Access Compliance Report

Public Rights-of-Way

Intersection ID: 19622	Main Street: SARDIS_RD	Cross Street: SARDIS_VIEW_RD	Location: SE
ADA ID: 06CBAAB1E58D	Ramp Type: PerpDiag	Initial Pass/Fail: Fail	Overall Compliance: No
Severity Score: 37.5			
Codes/Mitigation Info/Possible Solution		Field Measurements/Component Compliance

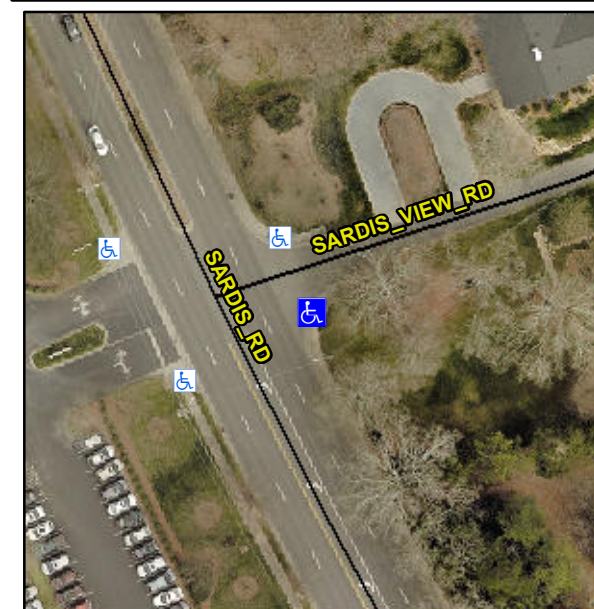
Not Found, R304.2.2, R304.5.3

Compliance	Description	Data	Compliance	Description	Data
N/A	Ramp Length (in)	59.0	No	Ramp Slope (%)	9.1
Yes	Ramp Width (in)	48.0	No	Ramp XSlope (%)	7.5
N/A	Flare Type LT	N/A	N/A	Flare Type RT	N/A
N/A	Flare Slope LT (%)	N/A	N/A	Flare Slope RT (%)	N/A
N/A	Flare Traversable LT?	N/A	N/A	Flare Traversable RT?	N/A
N/A	Landing Length (in)	N/A	N/A	DWS Provided?	N/A
N/A	Landing Width (in)	N/A	N/A	DWS Contrast?	N/A
N/A	Landing Slope (%)	N/A	N/A	DWS Length (in)	N/A
N/A	Landing X Slope (%)	N/A	N/A	DWS Full Width?	N/A
N/A	Landing Curb? (Y/N)	N/A	N/A	DWS Offset (in)	N/A
N/A	Shared Landing?	N/A			
N/A	Gutter Ponding?	N/A	N/A	Gutter Slope (%)	N/A
N/A	Gutter Lip Ht (in)	N/A	N/A	Gutter X Slope (%)	N/A
N/A	Painted X Walk1?	No	N/A	Painted X Walk2?	No
	X Walk 1 Direction	To N		X Walk 2 Direction	To W
N/A	X Walk 1 Width (in)	N/A	N/A	X Walk 2 Width (in)	N/A
	X Walk 1 Slope (%)	3.1		X Walk 2 Slope (%)	2.8
	X Walk 1 X Slope (%)	1.9		X Walk 2 X Slope (%)	4.2

Remove & Replace Curb Ramp With Two New Directional Ramps or Equivalent.
